WILLOWTREE PLANNING

**RE: RESPONSE TO FURTHER ADVICE - A006949411
576 ROYAL ESPLANADE MANLY QLD 4179**

Response to Further Advice

Figure 1. Site frontage and existing landscaping along Royal Esplanade (Google Streetview)

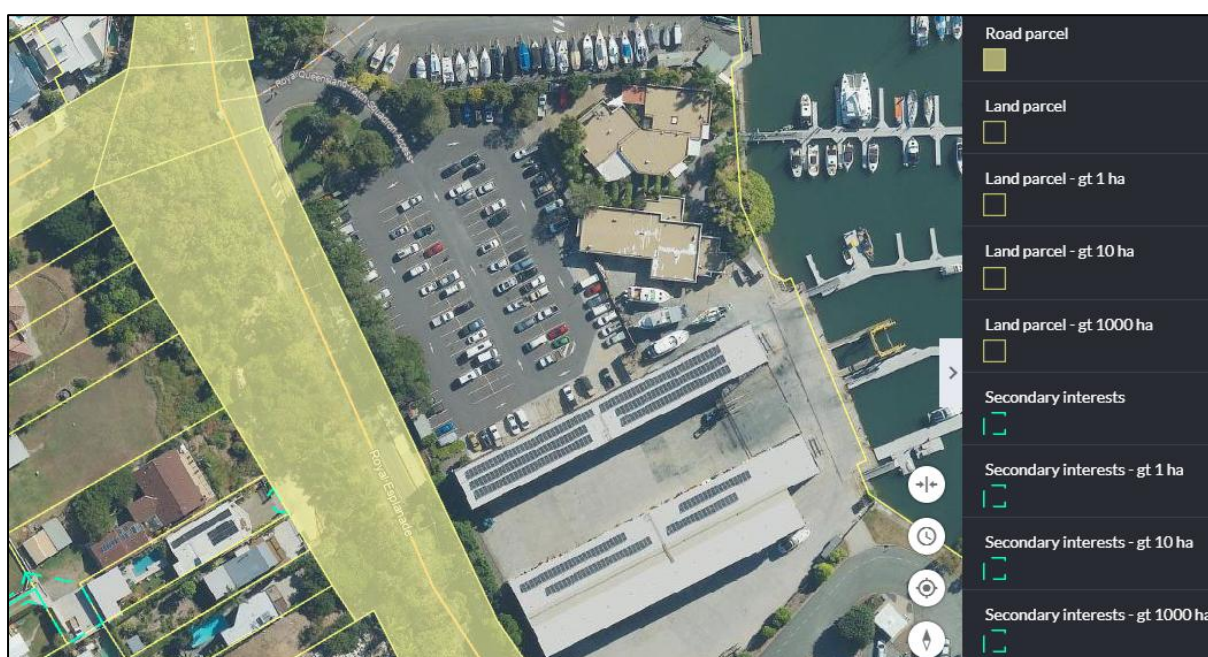
3. *The raised car parking structure results in the removal of existing vegetation and creates potential building bulk, and amenity impacts to the streetscape. The extent of landscaping and built form setbacks to the streetscape and the scale of the proposed structure are unclear based on the current plans. Further to this, where landscaping is indicated it appears to be within constrained growing conditions and impacted by building overhang.*

The Applicant also observes the residential properties on the opposite side of the Site are screened by significant landscaping within dedicated road frontage as pictured in **Figure 1** and **Figure 2** below. This landscaping is within the extent of Council's road reserve and provides extensive visual buffering between the residential properties and the development.

On the basis of the above, it is considered the proposed outcome is appropriate for the Site and compliance with PO15, PO18, PO28 and PO32 of the Specialised centre code has been achieved.
